Retaining Wall TMK: 4-7-019-049, 47-079 Kamehameha Hwy, Kaneohe, Hawaii

**FINAL
ENVIRONMENTAL ASSESSMENT FOR SHORELINE
SETBACK VARIANCE APPLICATION**

**After-the-fact Concrete Deck and
Slope and Shoreline Stabilization**

**City and County of Honolulu
Department of Planning and Permitting
Preparation of this Environmental Assessment is required for
Shoreline Variance application pursuant to Section 343-5(a)(3),
Hawaii Revised Statutes (HRS)**

Figures 1 & 2

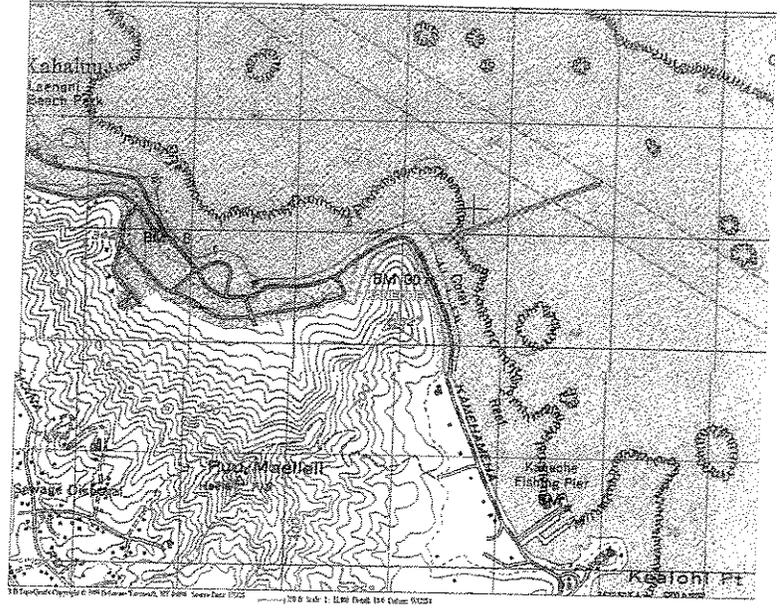
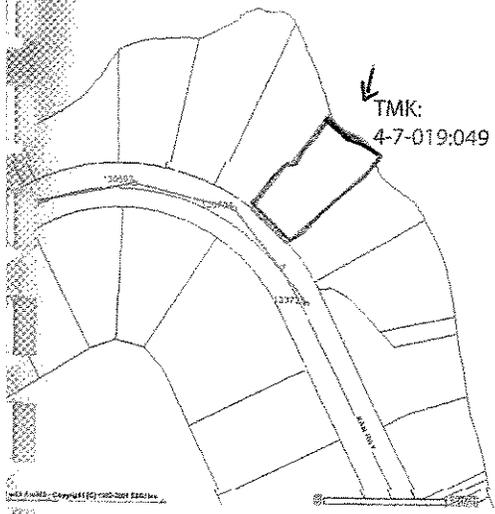
2. The location maps referenced as Figures 1 and 2, which are actually from the Geotechnical Engineering Exploration prepared by Applied Geosciences, LLC, are unnecessarily difficult to find. The Final EA should be revised to include location maps which are clearly labeled and attached to this section. We also find that the "Figures" listed in the Table of Contents are actually documents and correspondence from other parties (i.e., geotechnical firms, structural engineers, government agencies.). These "Figures" should more accurately be referenced as Attachments. Although they can remain appended to the end of the document, these documents should be labeled as an Appendix. Each appendix item should be separated by an identifying title page.

Site Plan

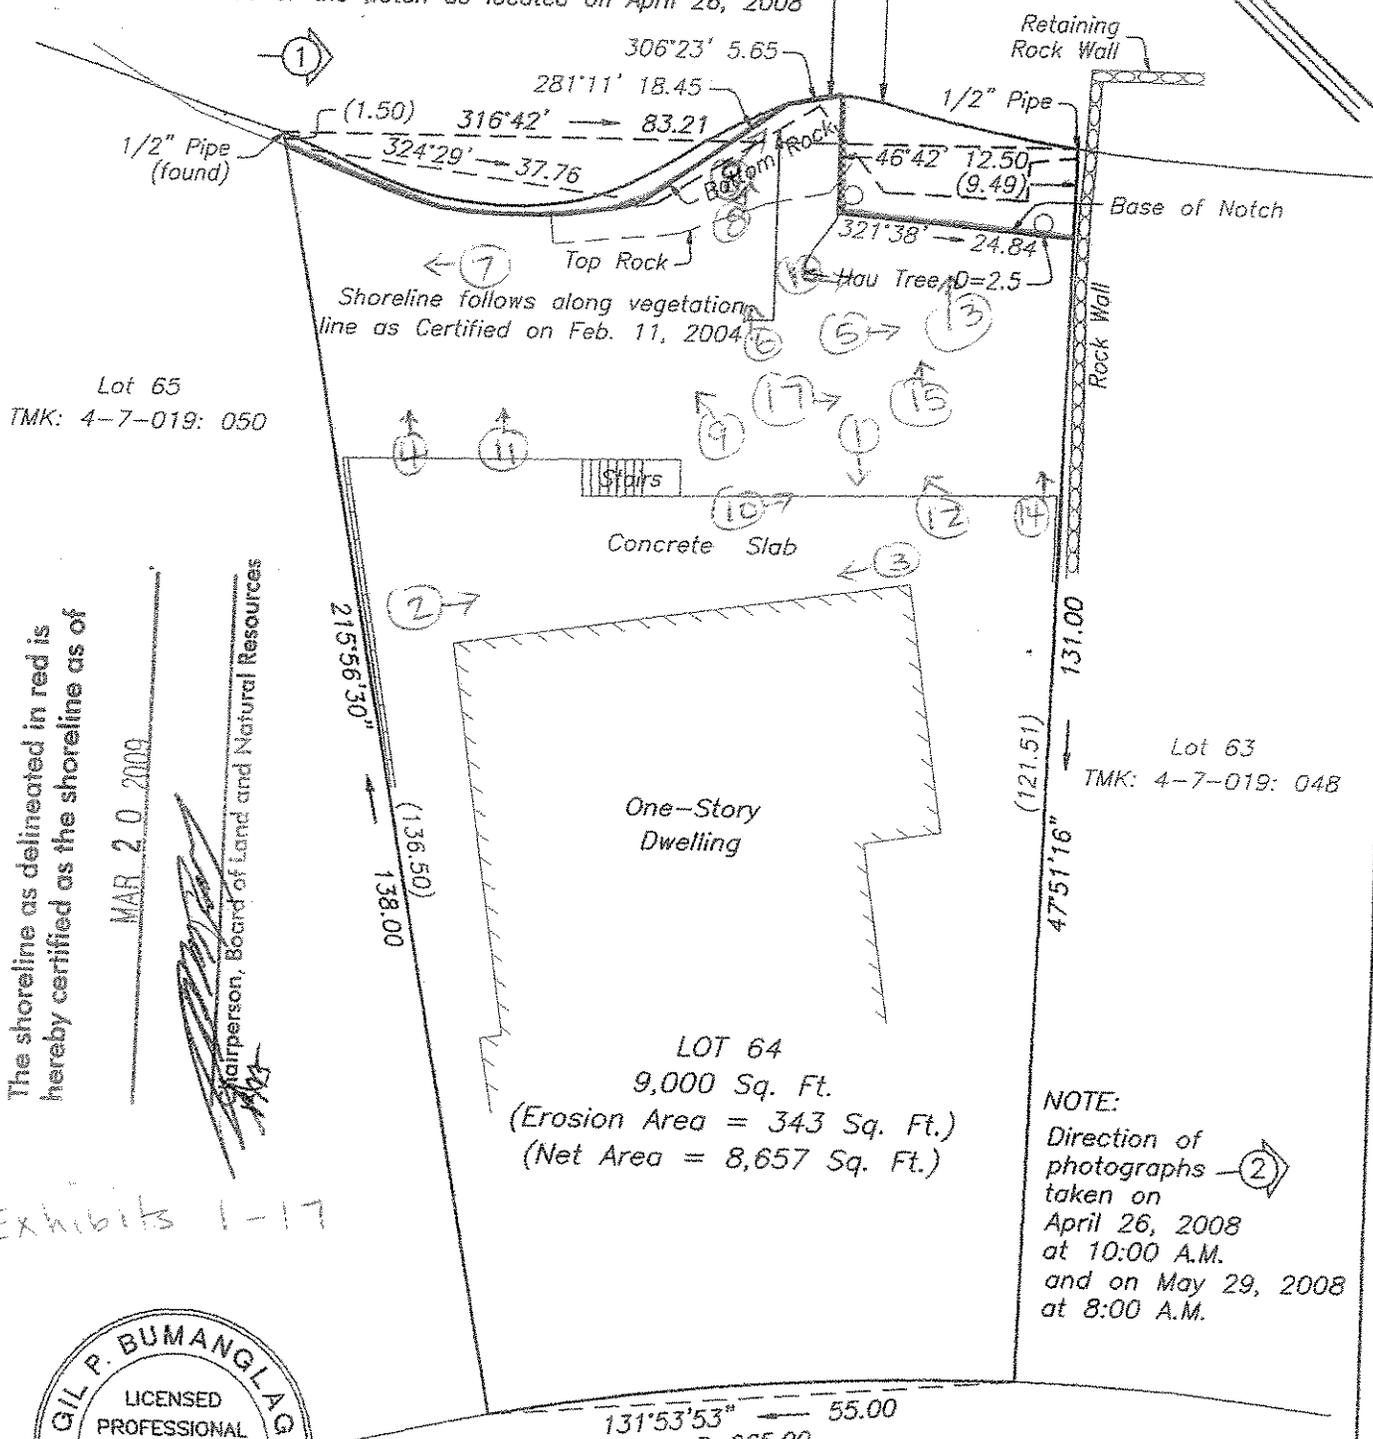
2. The site plan must show the property lines, existing structures, ground elevations, shoreline, and 40-foot shoreline setback line. The dwelling setback from the shoreline must also be shown.

1. This section of the Final EA should be revised to clearly describe that there are two (2) separate actions sought under the application: A) Retaining the existing deck structure; and B) Constructing three (3) proposed structures, which include a seawall and two (2) retaining walls.
2. This section should describe the entire site (outside the shoreline setback), including the size and type of dwelling construction, its orientation on the site in relation to other setbacks, as well as other improvements (i.e., drive and walkways, drainage features, fences or other retaining walls). A brief history of the site should also be provided (i.e., when was it subdivided, when was the dwelling built, etc.). Additional exhibits, including a site plan as well as photographs would be useful.

1. This final EA has clearly differentiated between the two projects.
2. A new site plan has been included along with the photos for your reference. The shoreline and property line are clearly noted. Information regarding the dwelling has been included.

Stability Analysis - Line AA

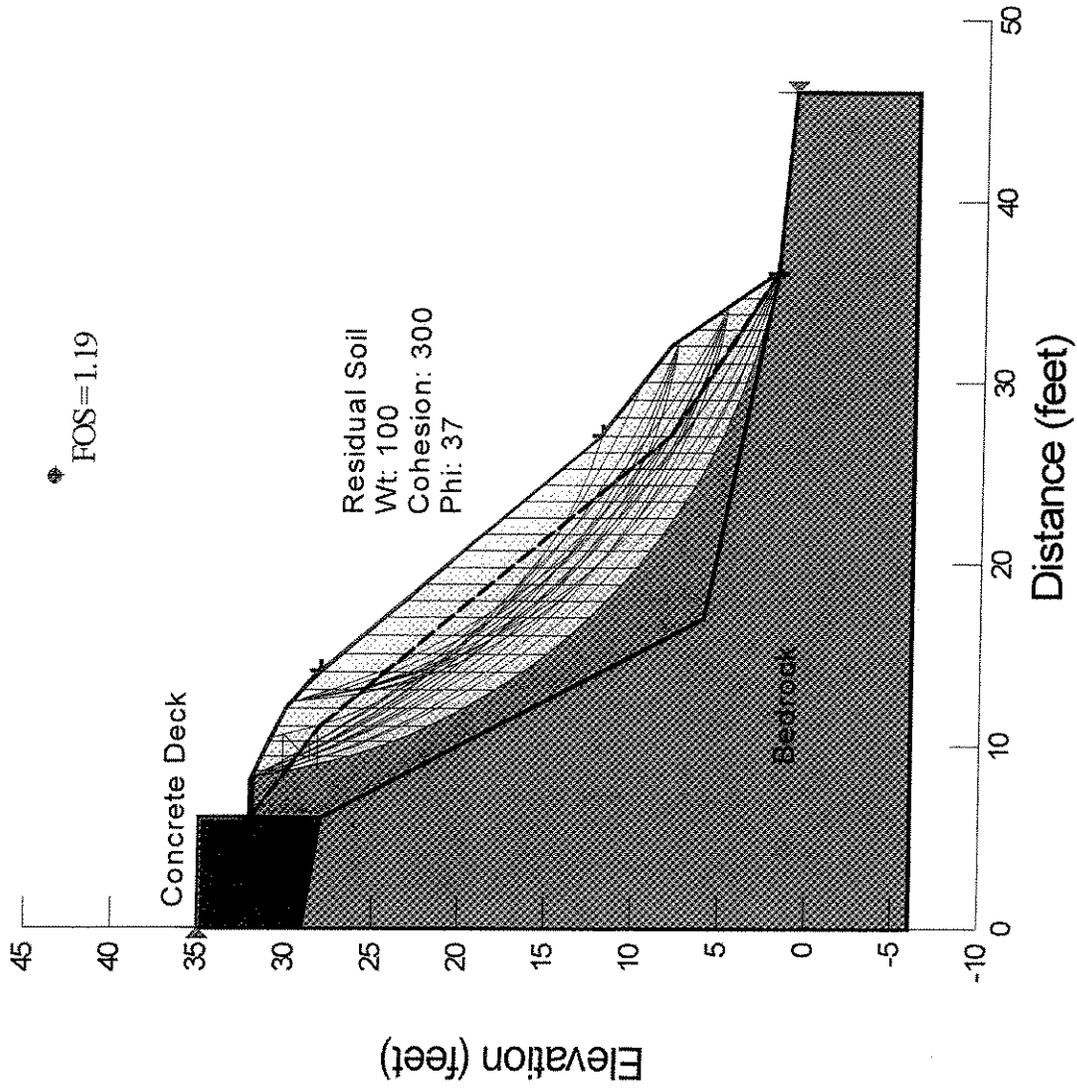
Engineering Analysis - Our Site Development Division noted the follow: In addition to the engineer stamp and signature, the report (Geotechnical Engineering Exploration) should have included the authentication statement and expiration date of the engineer's license pursuant to Section 11-115-9, Hawaii Administrative Rules. The engineer should also provide a soils report conformance letter stating that he has reviewed the plans for the proposed improvements and that those plans are in conformance with the recommendation of his report. In addition, although the report states that some sort of tie-back system will need to be installed in order to provide the necessary stability, no recommendations were presented. In addition, please clarify if the terraced retaining system addresses slope stability. If so, what is the factor of safety of slope stability after the improvements are constructed? If not, why are recommendations not included to address slope stability?

Engineering Analysis: The Geotechnical Engineer has placed his stamp on his report. He also viewed the plans and stated that they are in conformance with his recommendations. The terraced retaining system definitely addresses slope stability and it has been stated in the EA. The slope stability will clearly address the safety factor. The number will be significantly higher than it is now (1.0).
